Well Name: TONKIN FEDERAL	Well Location: T27N / R12W / SEC 23 / SENE / 36.563889 / -108.074066	County or Parish/State: SAN JUAN / NM
Well Number: 1E	Type of Well: OTHER	Allottee or Tribe Name:
Lease Number: NMNM02691	Unit or CA Name:	Unit or CA Number:
US Well Number: 300452602800S1	Well Status: Inactive	Operator: EPIC ENERGY LLC

Type of Action: Plug and Abandonment

P&A Procedure

CONDITIONS OF APPROVAL

Current WBD

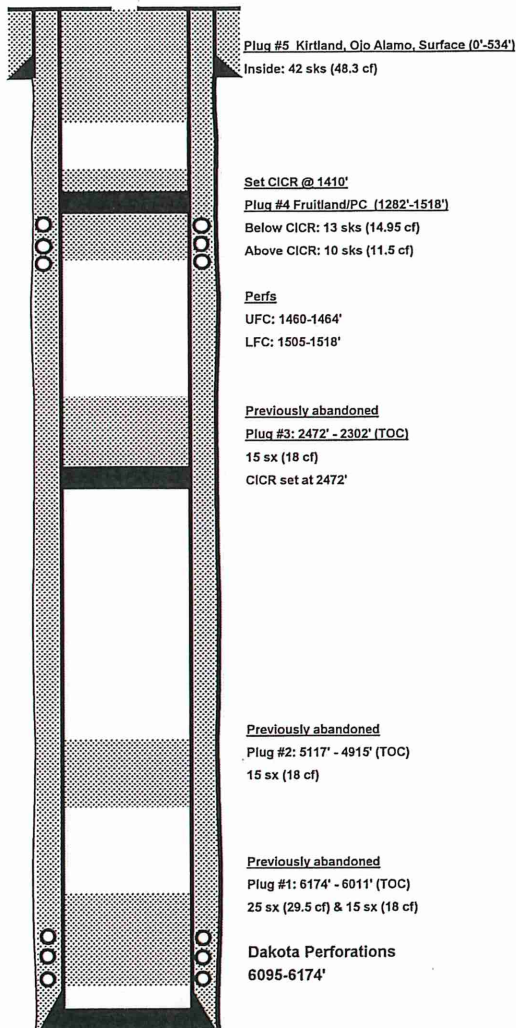
- BLM picks for the top of the Pictured Cliffs, Chacra, Kirtland and Ojo Alamo formations vary from Operator picks.
- Note: in the "Current WBD" submitted by operator, the well location information and API number are incorrect. They are correct elsewhere in the NOI.
